# PENSHURST PUBLIC SCHOOL UPGRADE

## CIVIL ENGINEERING DRAWINGS

PERUMAL PENSHURST PUBLIC SCHOOL 18 Arcadia Street, Penshurst STANDARD NOTES

SCALE - @ A CHECKED 10 MAY 2019 Drawing Number Revision 3199 - CIV- CD- <mark>01 001</mark>

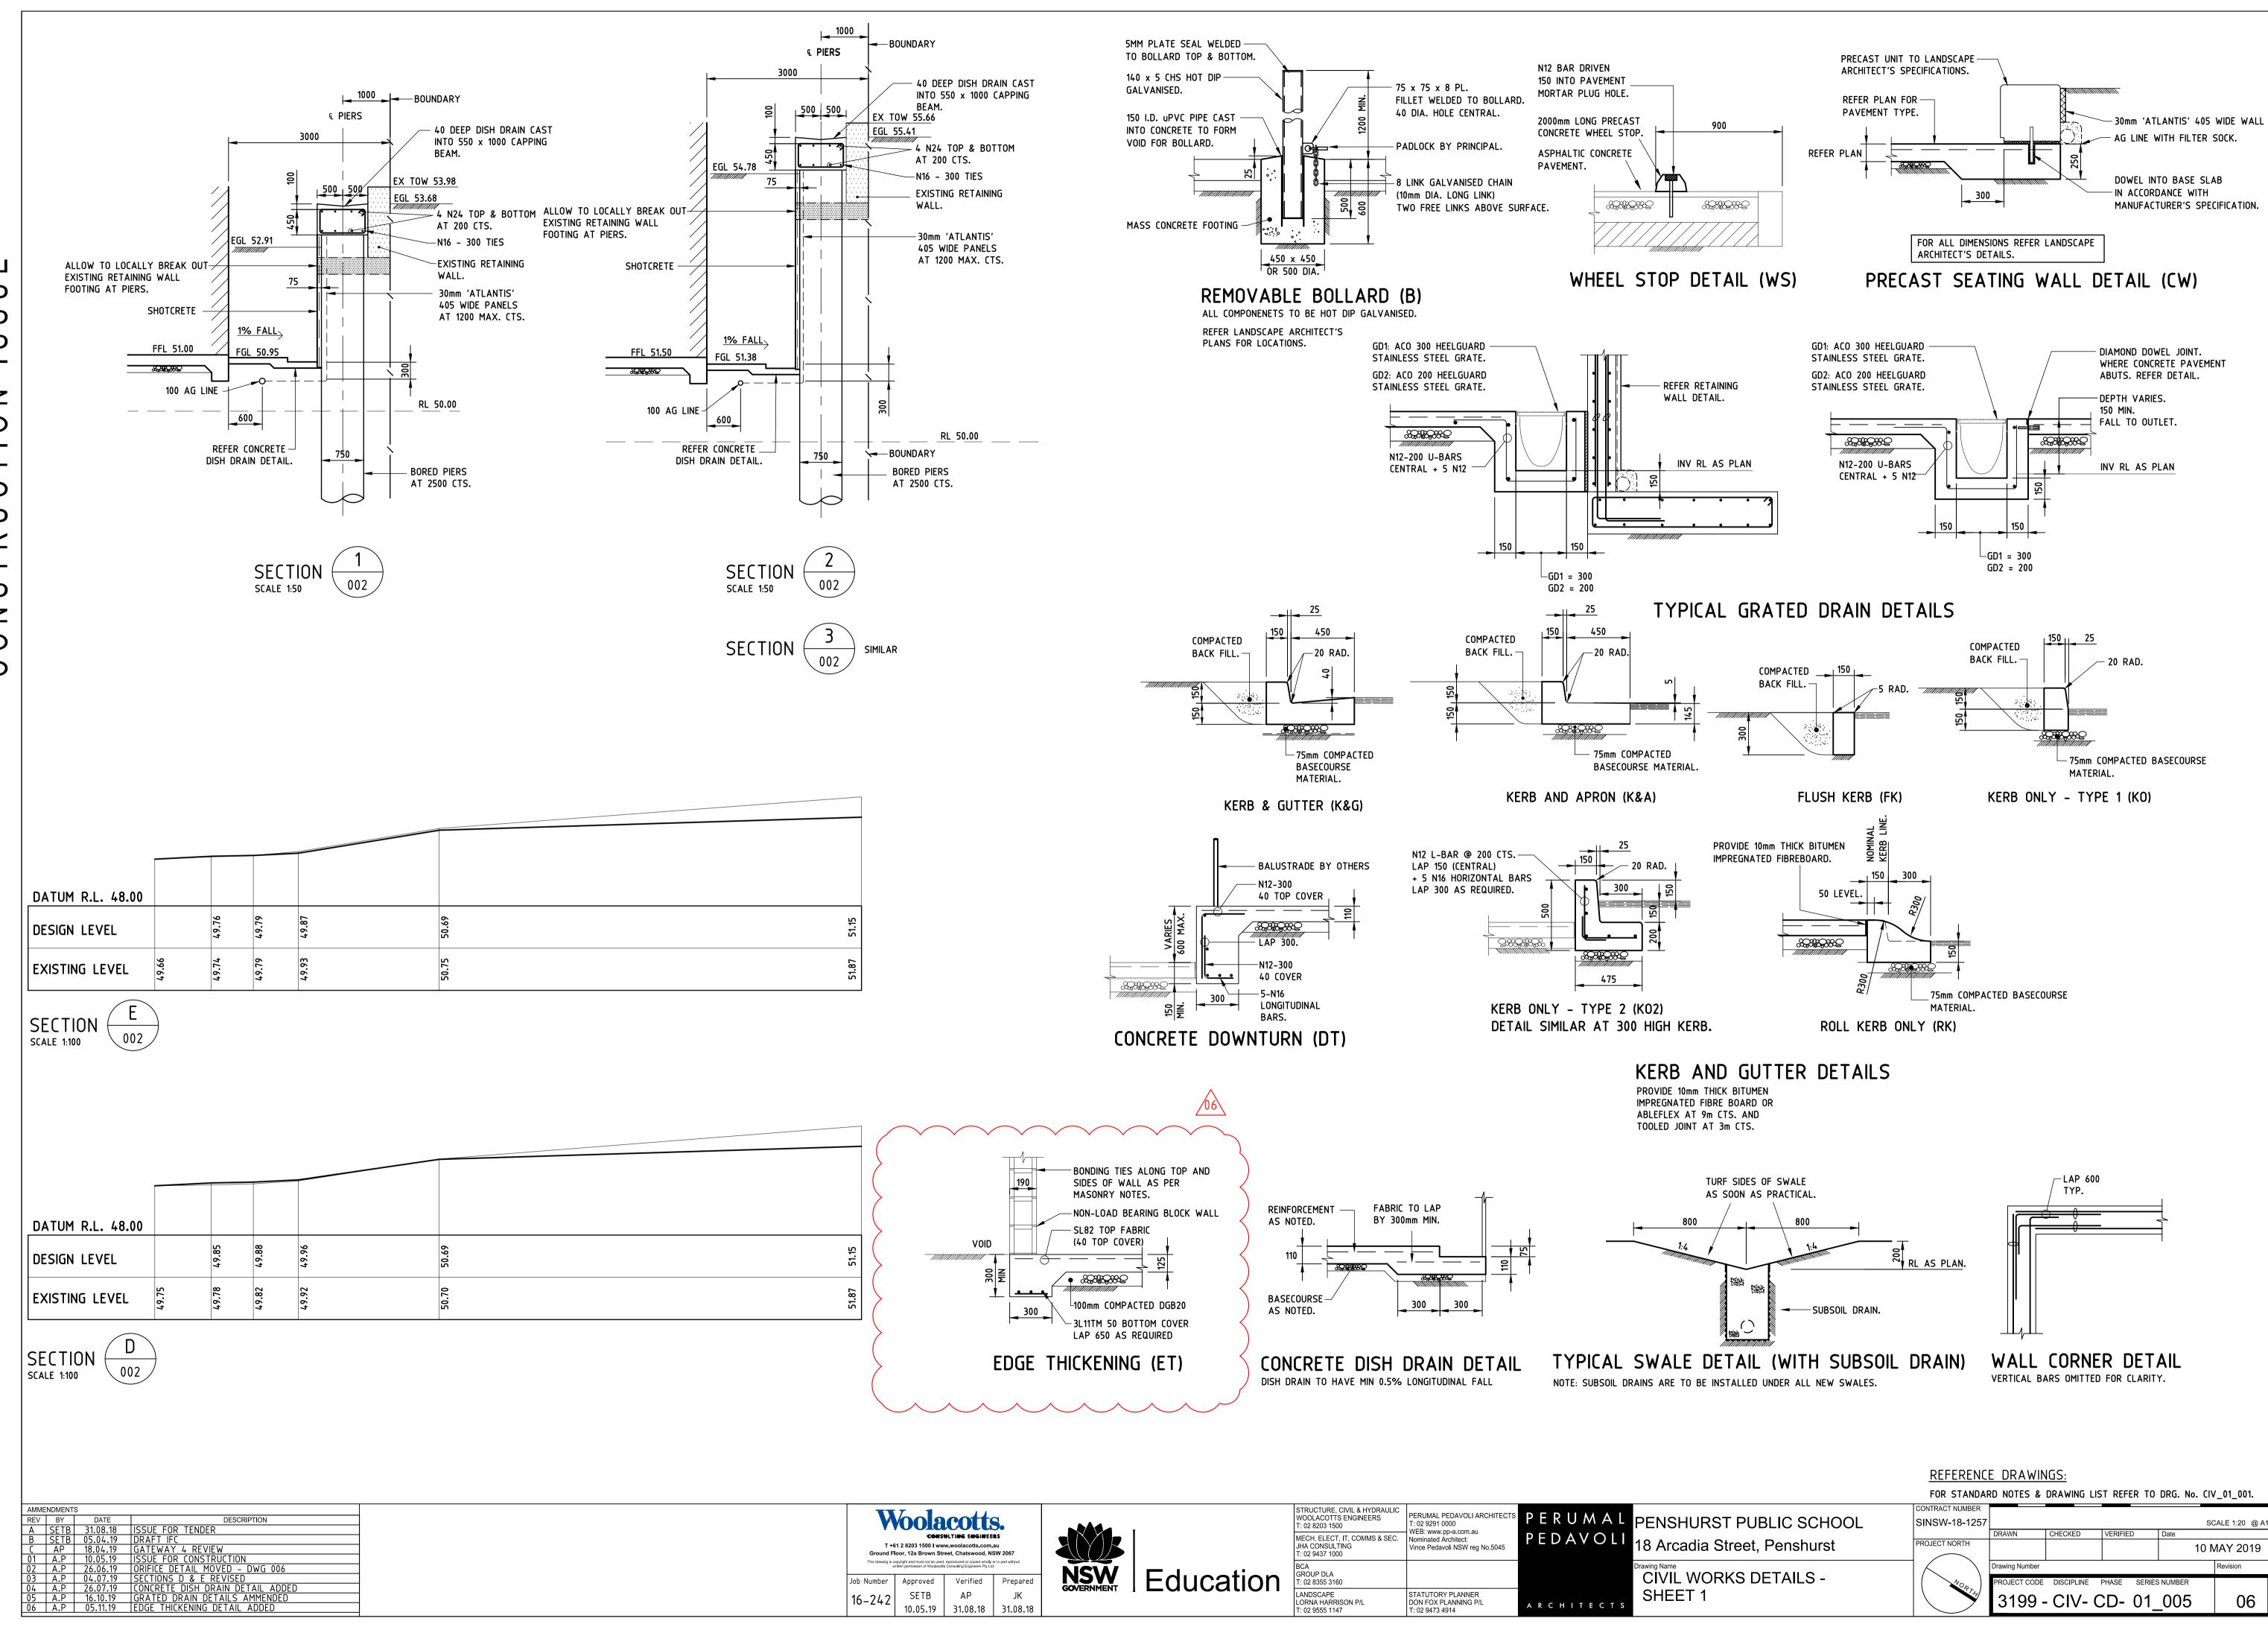
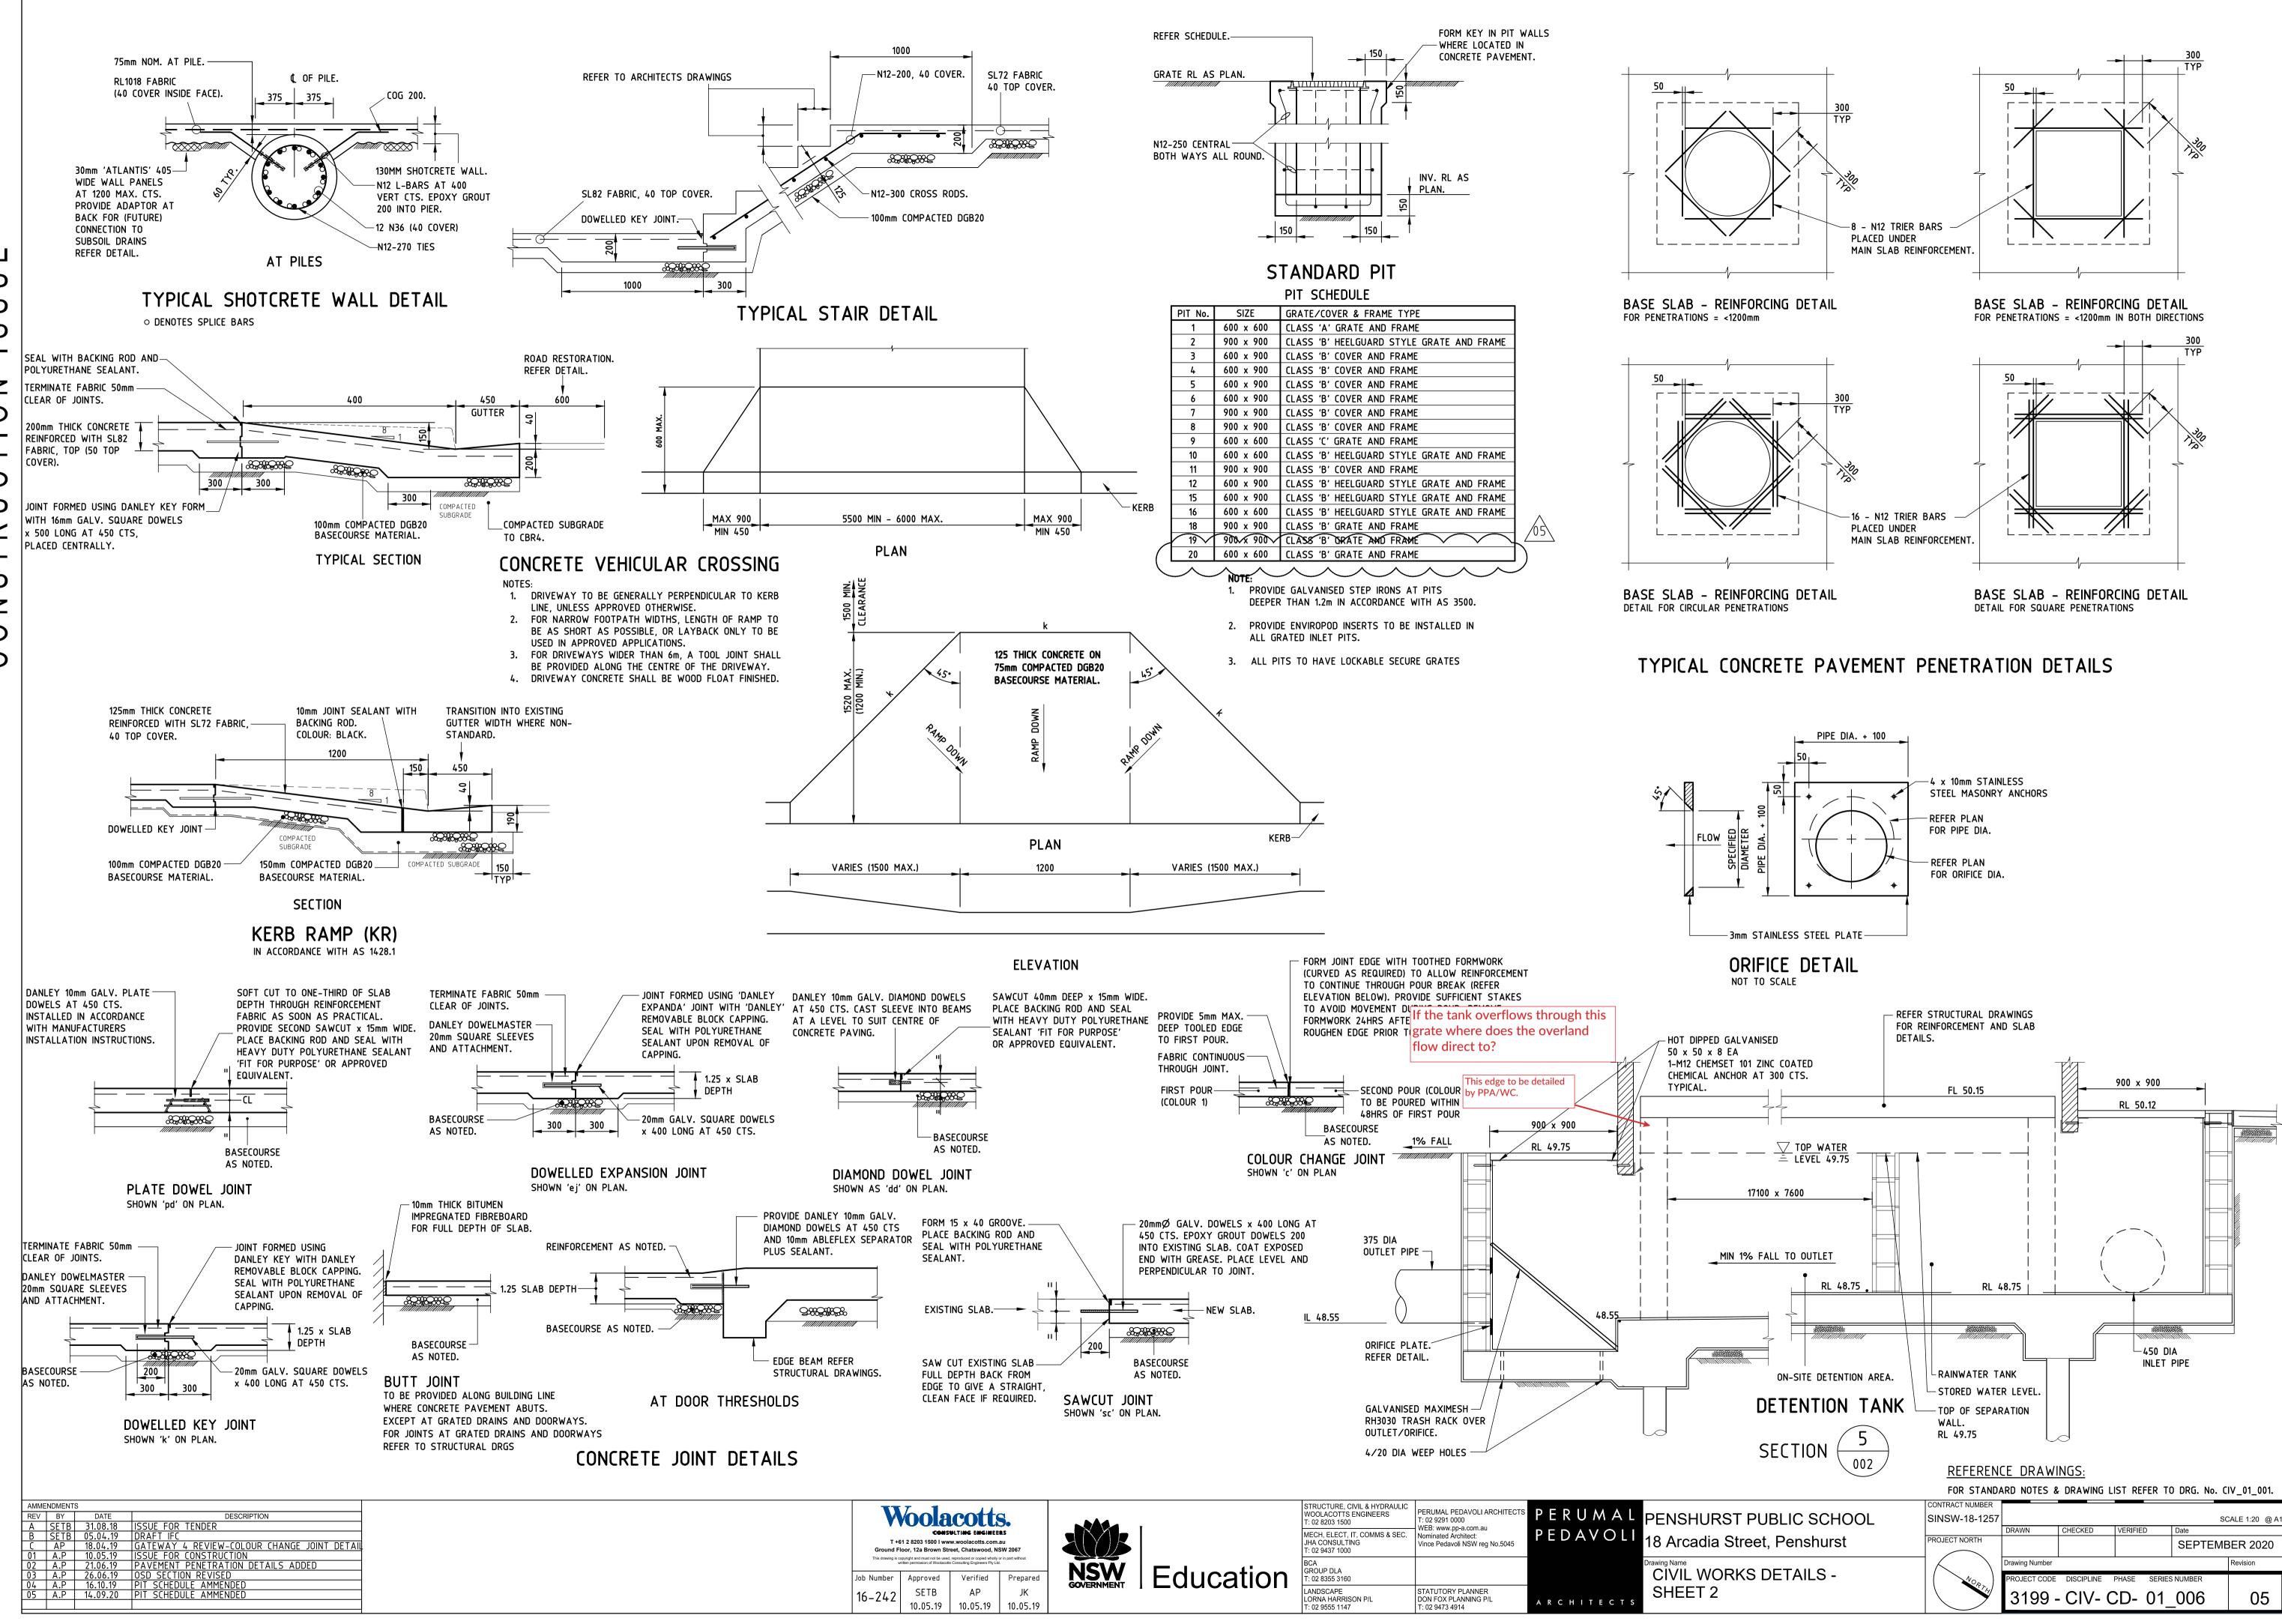
Thickness of pavement amended from 110mm to 125mm. WCE say they can go back to 110mm. Why did they change it in the first place?
